**ACCESSIBILITY SELF-EVALUATION AND TRANSITION
PLAN
SANTA MONICA MOUNTAINS NATIONAL RECREATION
AREA
CALIFORNIA**

NOVEMBER 2022

06 Vault Toilet on the Right

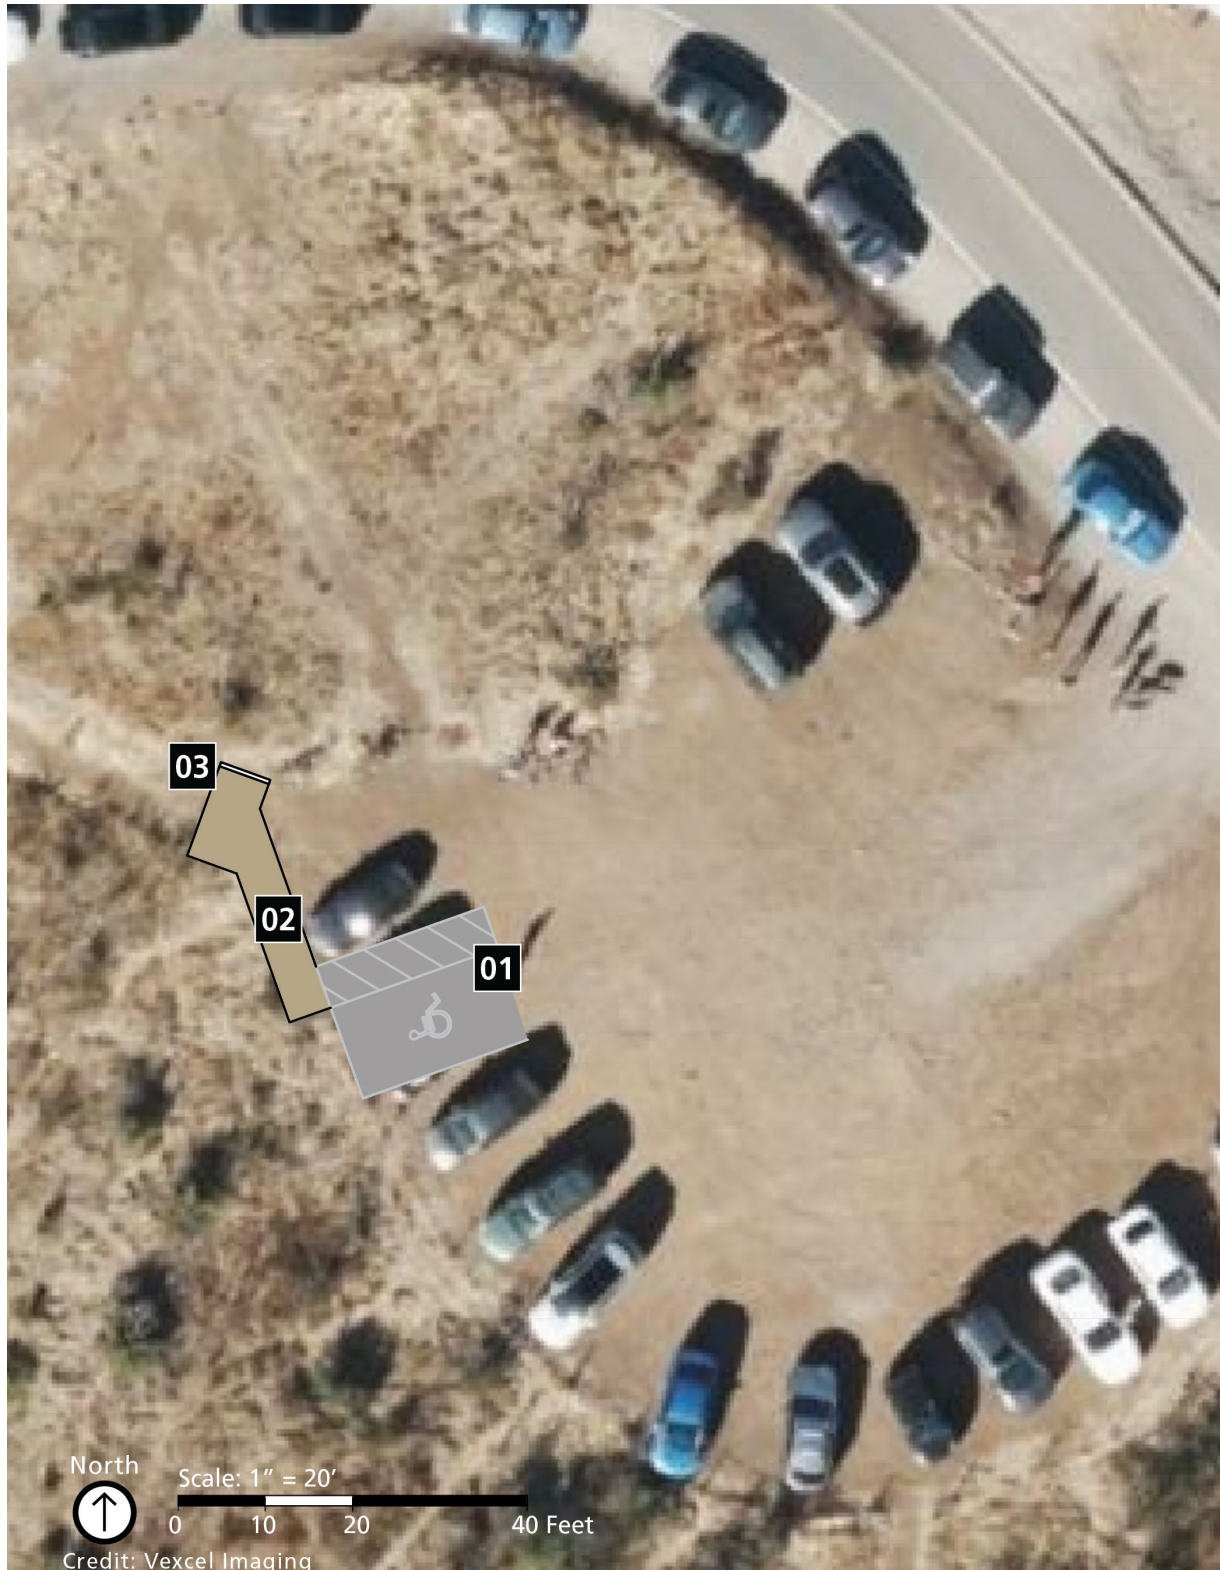
- 1) As a best practice, reduce the force required to open the door to be 10 pounds maximum.
- 2) Relocate the toilet paper dispenser below the side wall grab bar. The top shall be at least 1 1/2" from the bottom of the grab bar.

03 Kiosk

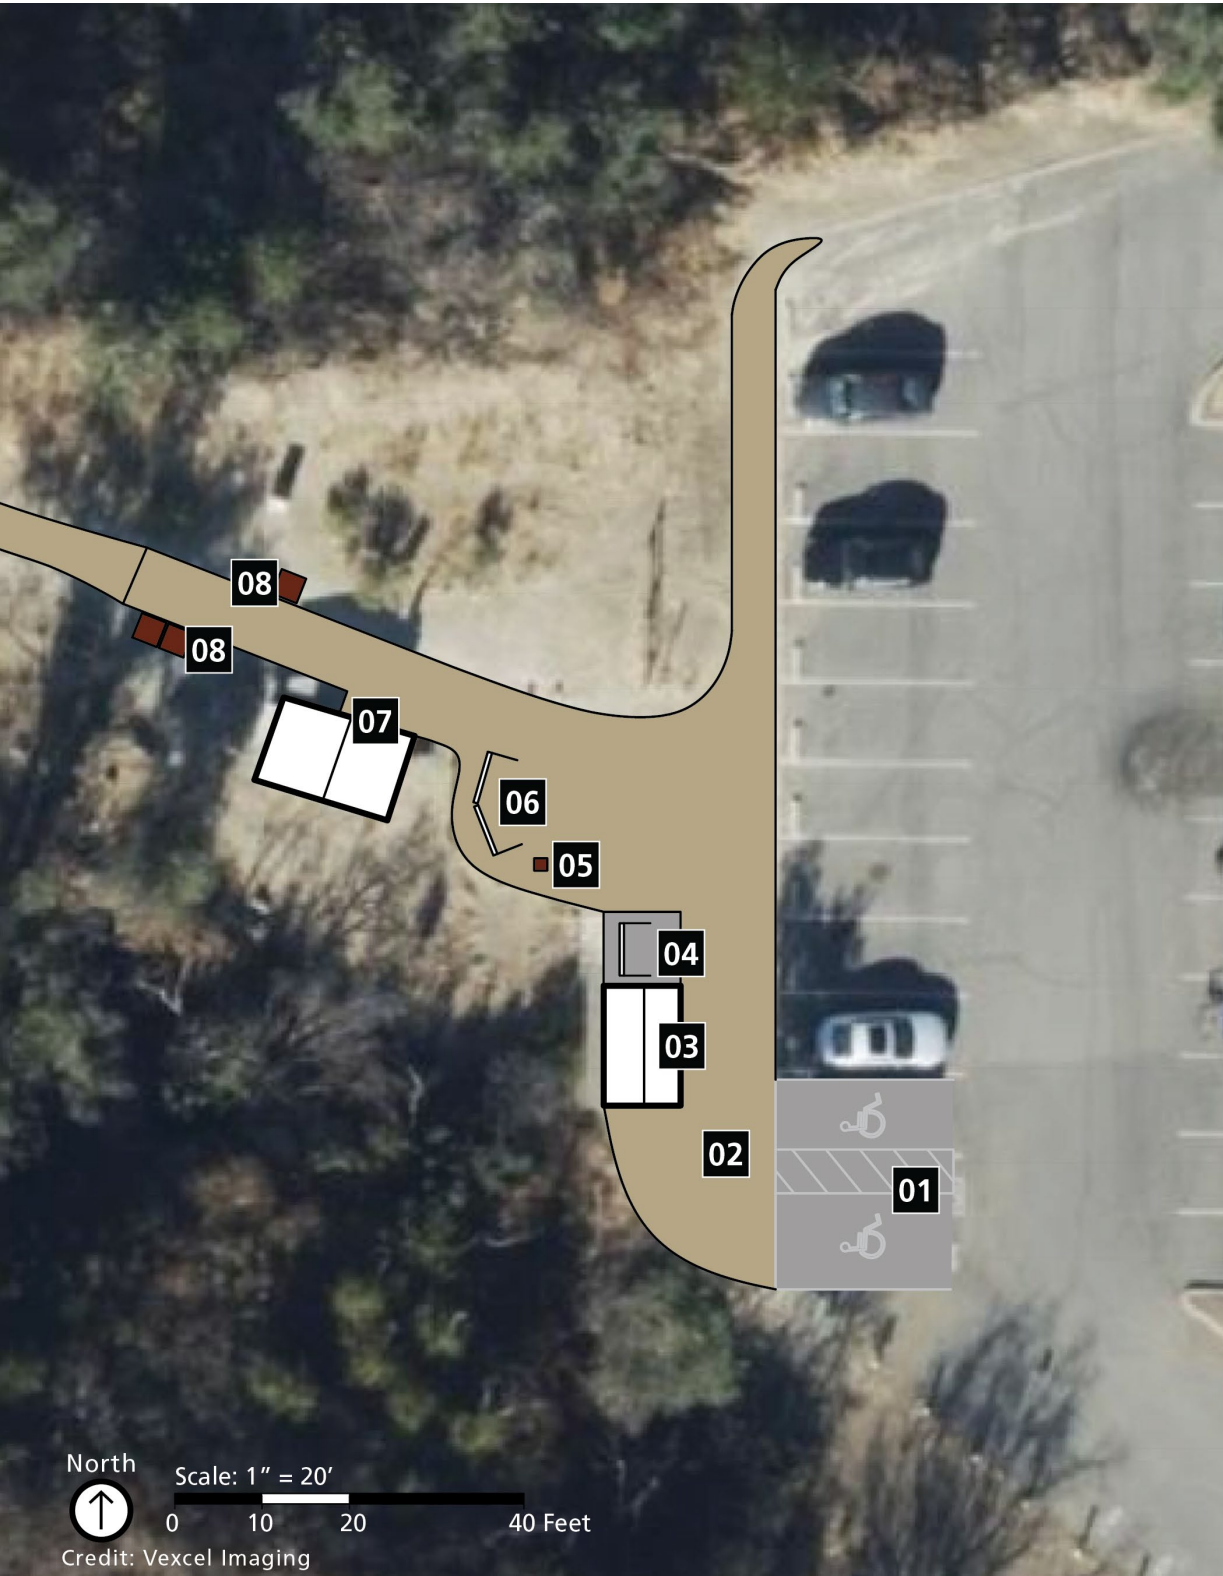
- 1) Provide signage at the trailhead that details trail conditions, including trail length, surface type, typical and maximum running and cross slopes, and typical and minimum tread width. Other recommended information includes providing a description of potential obstacles, distances to experiences and/or features, and graphics such as a cross section that demonstrate slope conditions.

- 2) Add a duplicate kiosk near the accessible parking in an accessible location with a 30" by 48" minimum clear ground space in front at a 2% maximum slope in all directions. On the inaccessible kiosk, provide a note or sign alerting visitors to the duplicate accessible kiosk.

Picnic Facilities

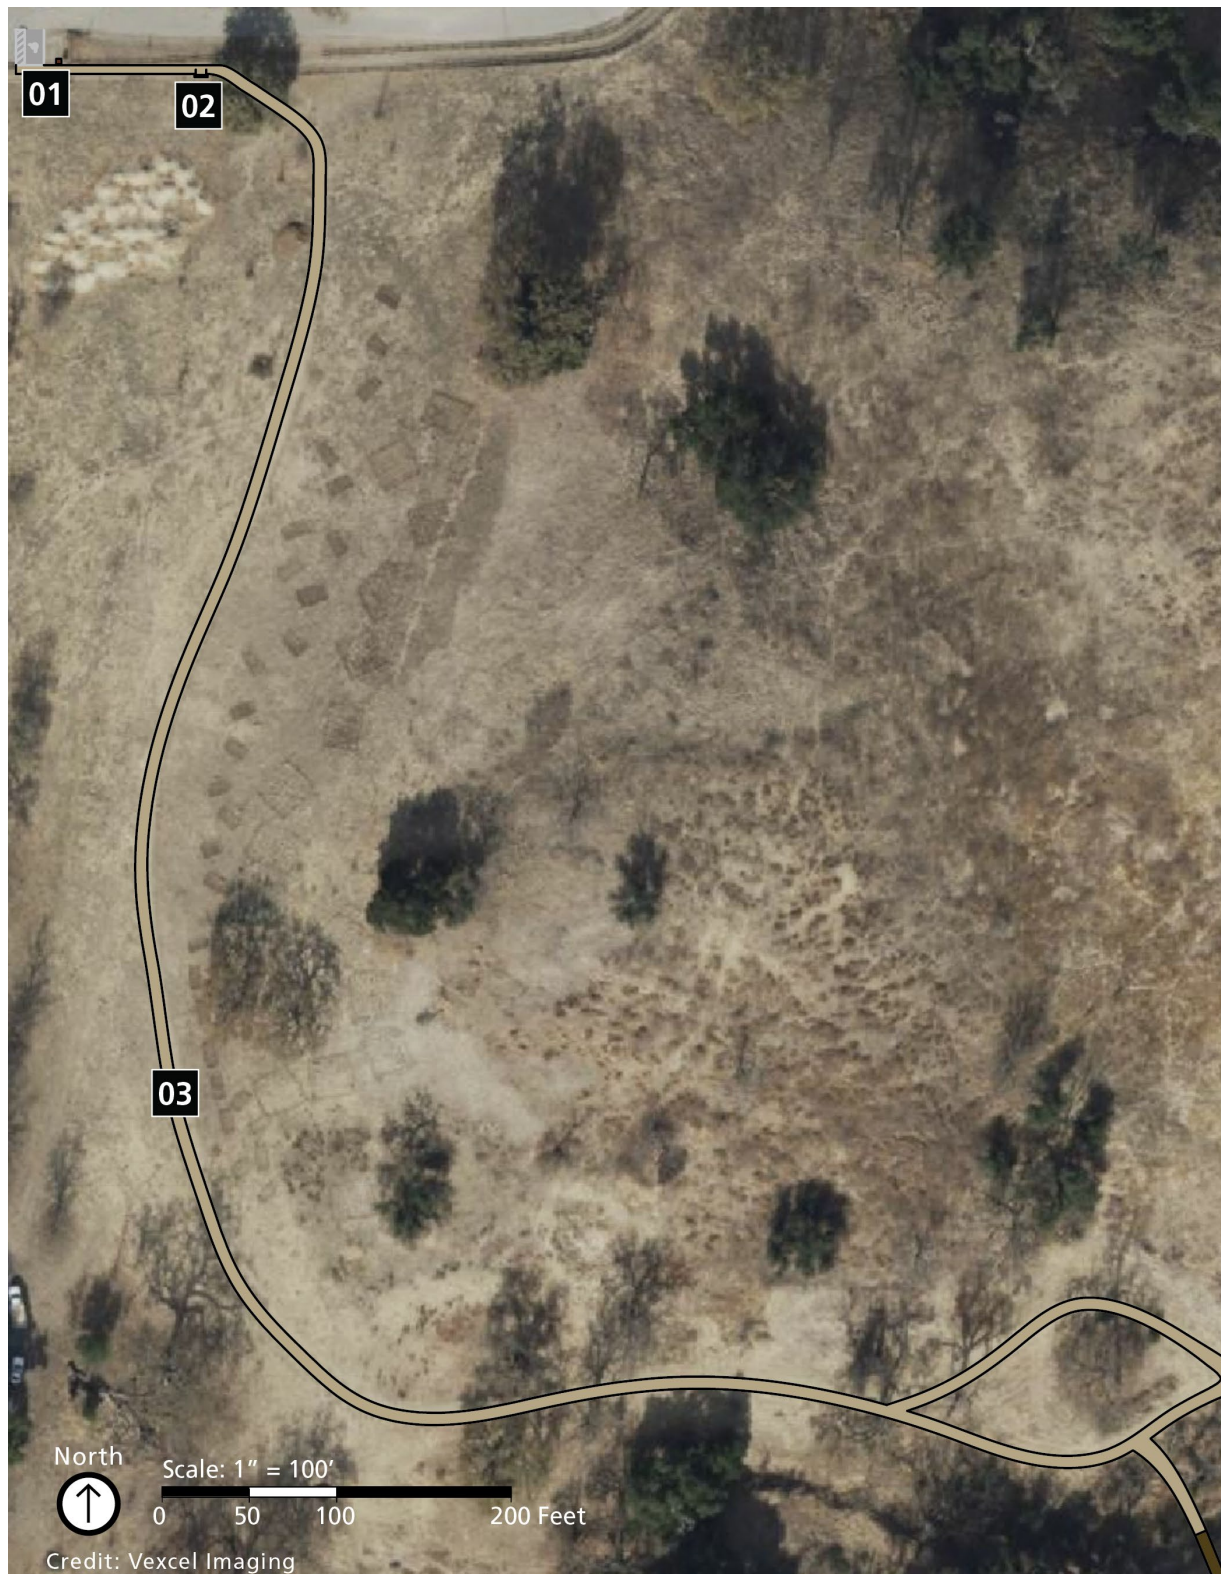
- 1) Provide 36" minimum width clear ground space on all usable sides of accessible tables.

03**Trail**

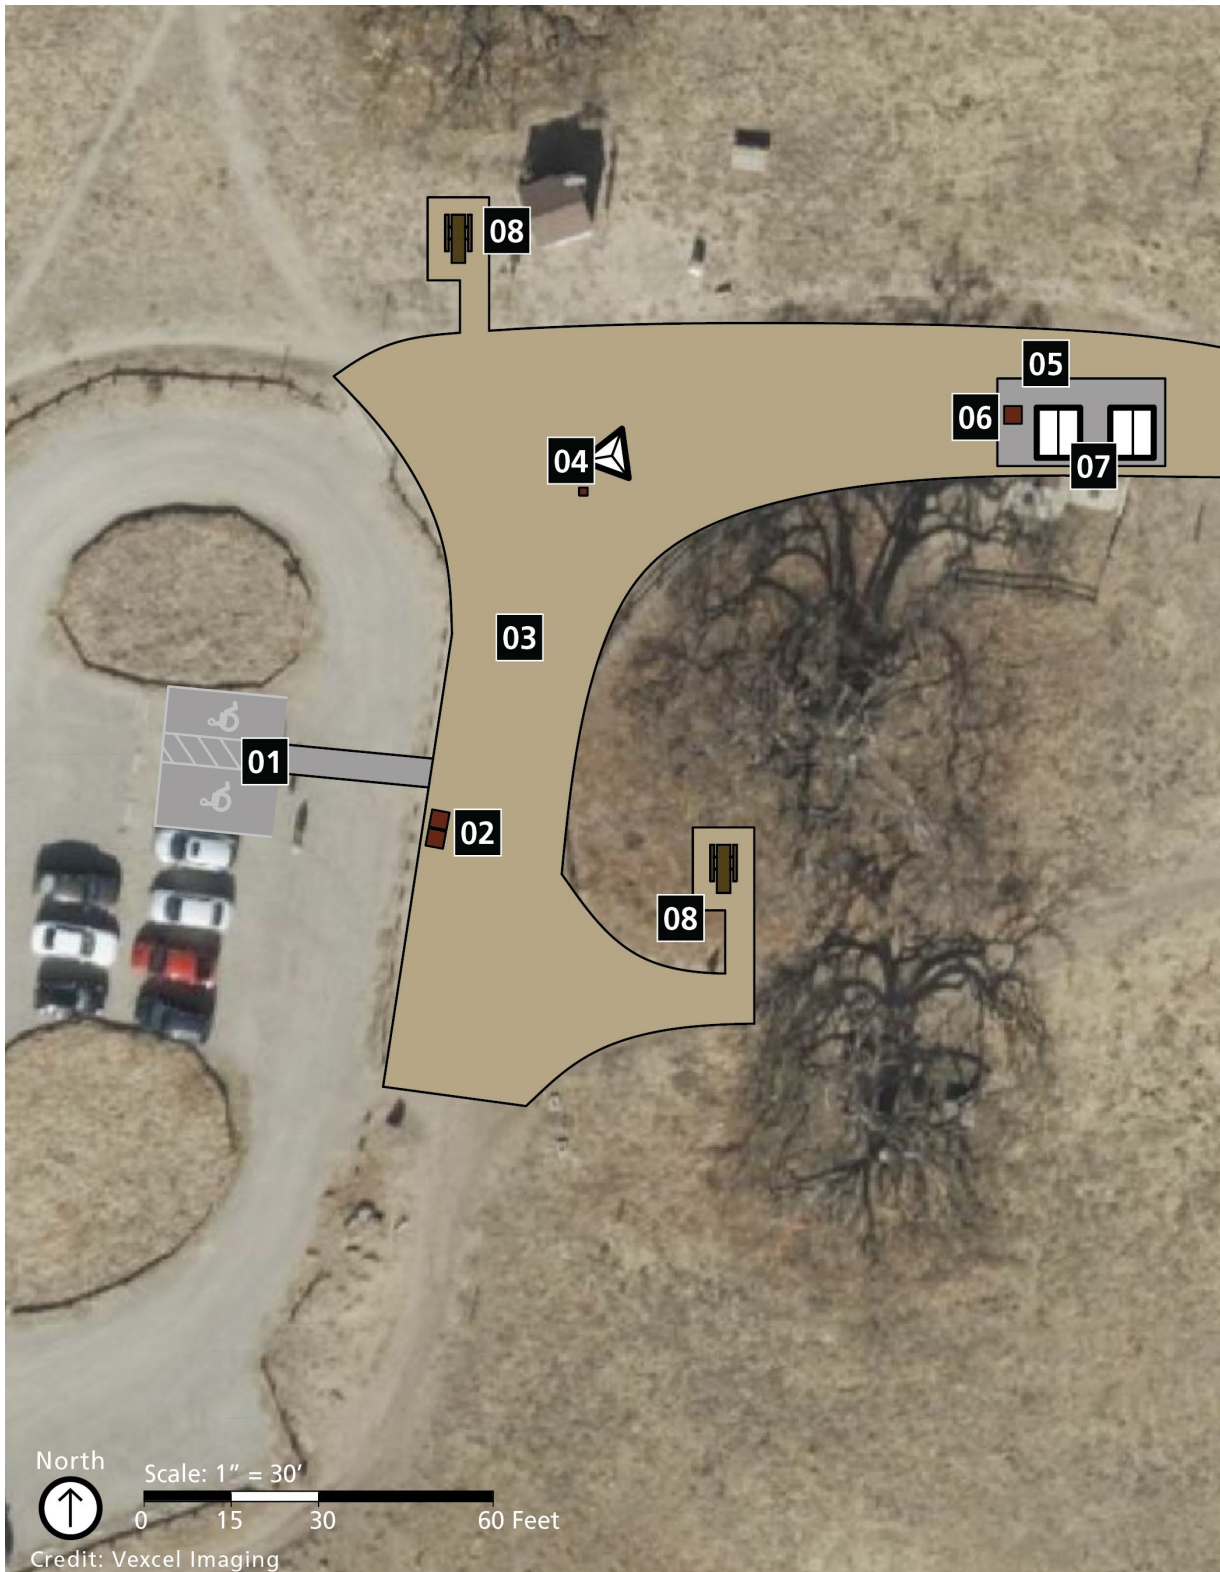
- 1) As a best practice and to make as much of the trail usable as possible, removing large vertical obstacles and openings would provide more access to visitors. As possible, improve cross slopes to be no more than 2%, or up to 5%, for drainage purposes.

Kiosk

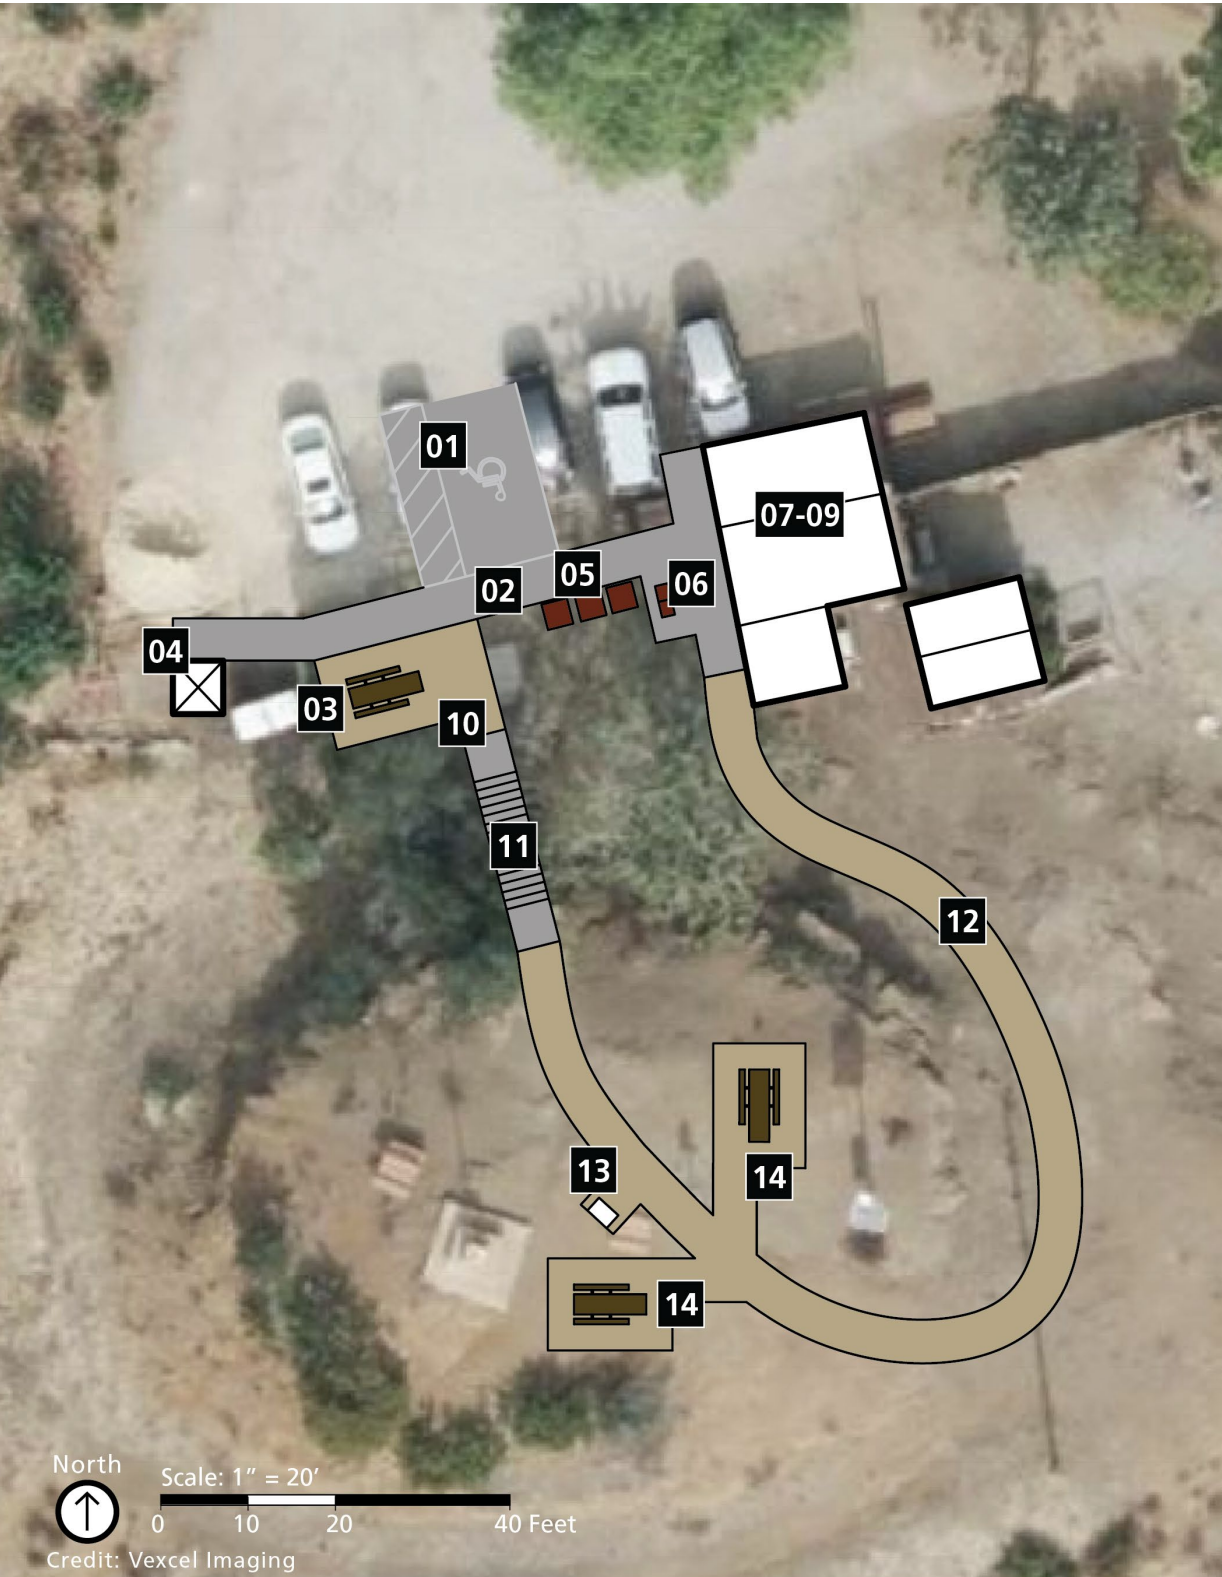
- 1) Provide signage at the trailhead that details trail conditions, including trail length, surface type, typical and maximum running and cross slopes, and typical and minimum tread width. Other recommended information includes providing a description of potential obstacles, distances to experiences and/or features, and graphics such as a cross section that demonstrate slope conditions.
